UNITED STATES PATENT AND TRADEMARK OFFICE

APPLICATION NO.	FILING DATE	FIRST NAMED INVENTOR	ATTORNEY DOCKET NO.	CONFIRMATION NO.
09/917,959	07/30/2001	Tomoyuki Taguchi	JP920000005US1 (14606)	9354

Office Action Summary	Application No. 09/917,959	Applicant(s) TAGUCHI, TOMOYUKI	
	Examiner emily y chan	Art Unit 2829

DETAILED ACTION

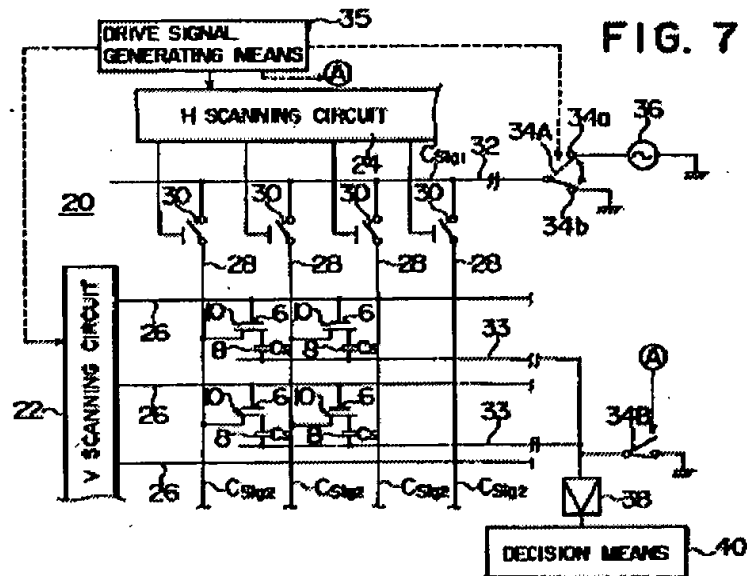
Suzuki et al ('030) disclose an inspection method for an array substrate as claimed (see fig 7) below, in which the array substrate comprises: a substrate (5); a plurality of gate lines (26); a plurality of signal lines (28); a plurality of common power source terminal line (33); a plurality of switching elements (6, 30) electrically connected respectively to the a plurality of gate lines (26) and to the a plurality of signal lines (28); and a plurality of storage capacitors (8) electrically connected respectively to the plurality of common power source terminal line (33) and to the plurality of switching elements (6) (see 5, lines 30-35). Suzuki et al ('030) expressly teach (see col. 7, lines 12-20 and col. 11, lines 1-5) that:

- (1) Applying voltage from the plurality of common power source terminal lines (33) to the plurality of storage capacitors (8) (See Col. 7, lines 14-16 " the voltage from the common power source terminal line 33 is applied to the capacitor element 8");
- (2) Applying voltage signal (V1) from the plurality of signal lines (28) to the plurality of storage capacitors (8) via a plurality of switching elements (6, 30); and
- (3) Measuring quantities of charge stored in the storage capacitors (8) by a circuit (40) (see Col. 7, lines 51-55) based on potential difference between the two voltage signals (V1 and " voltage from the common power source terminal line 33" (see col. 7, lines 12-20, 35-38 and lines 52-55).

Suzuki et al ('030) does not teach the step of applying pulse signals from a plurality of storage capacitor lines to the plurality of storage capacitors.

FIG. 10

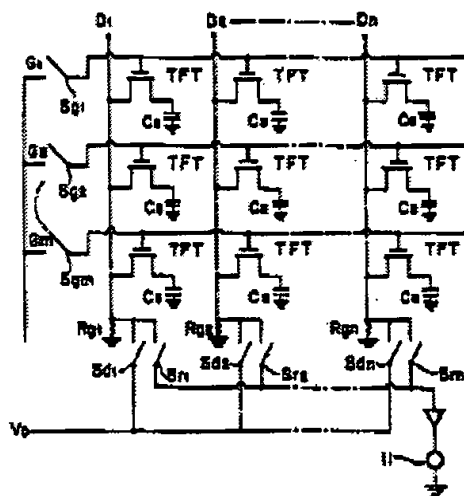
Takahashi et al ('300) disclose a method and apparatus for testing TFT-LCD and expressly teach a circuit (waveform analyzer 11) for measuring the quantities of

discharge released from the storage capacitor (see Fig 10 below) is connected to signal lines (D1...Dn) through relays (Sr1...Srn).

It would have been obvious to one of ordinary skill in the art at the time the invention as made to incorporate the teaching of Takahashi et al ('300)' measuring circuit connected to the signal lines into Suzuki et al ('030) in view of Tomitam ('061)' s device, because by using a relay, whether or not the TFTs corresponding to the individual pixels are properly connected can be determined efficiently as disclose by Takahashi et al ('300) (see col. 6, lines 25-30).
